**Comments and secretariat observations on "Safety rules for the construction and installation of lifts — Lifts for the transport of persons and goods — Part 20: Passenger and goods passenger lifts "**

Date: 2nd of April 2012	Document:  Draft prEN 81-20:2011
----------------------------	--

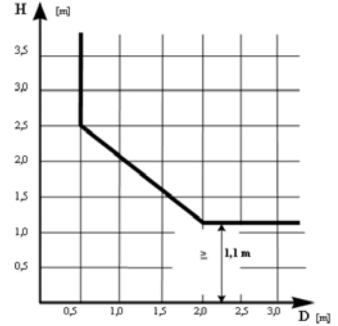
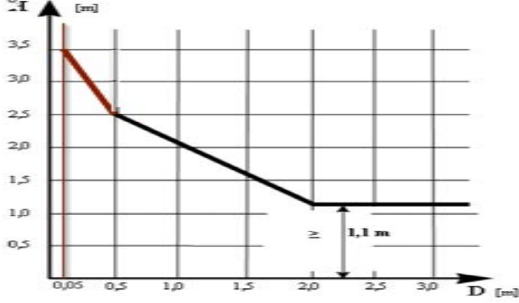
95 ES	5.2.5.2.2 a) 2)	Figure 2	te	<p>Partially enclosed well:</p> <p>Where the well .....</p> <p>The height is assumed to be sufficient if it is in conformity with figure 1 and 2, that means:</p> <p>1) minimum 3,50 m at a landing door side;</p> <p>2) minimum 2,50 m at other sides and with a minimum horizontal distance of 0,50 m to moving parts of the lift.</p> <p>If the distance to moving parts exceeds 0,50 m, the value of 2,50 m can be reduced progressively to a minimum height of 1,10 m in a distance of 2,0 m;</p> <p>b) ...</p>	<p><u>2) minimum 3,50 m at other sides and with a minimum horizontal distance <math>\geq</math> 0,05 m to moving parts of the lift.</u></p> <p><u>If the distance to moving parts exceeds 0,05 m, the value of 3,50 m can be reduced progressively to a minimum height of 2,5 m in a distance of 0,5 m; or the value of 2,50 m can be reduced progressively to a minimum height of 1,1 m in a distance of 2,0 m. (see Figure 1 and Figure 2)</u></p> <p>b) ...</p>

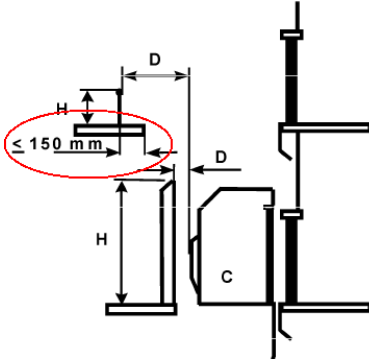
<p>Figure 2 - Partially enclosed well - Distances</p> <p>Our concern:</p> <p>The minimum height H for the enclosure is 3,5 m at a landing door side (see 5.2.5.2.2 a) 1)); which is considered as safe.</p> <p>We are of the opinion that the height of the enclosure at other sides (see 5.2.5.2.2 a) 2)) by a <math>D \leq 0.5</math> is unnecessarily stronger.</p> <p>Examples based on existing clause:            For <math>D = 0.51</math> m; <math>H_{\min} = 2.49</math> m            For <math>D = 0.50</math> m; <math>H_{\min} = 2.5</math> m            For <math>D = 0.49</math> m; <math>H_{\min} \rightarrow</math> full height !!!</p>	 <p>Figure 2 - Partially enclosed well - Distances</p> <p><a href="#">Figure 2 modified</a></p>	
--	--	--	--	---	--	--
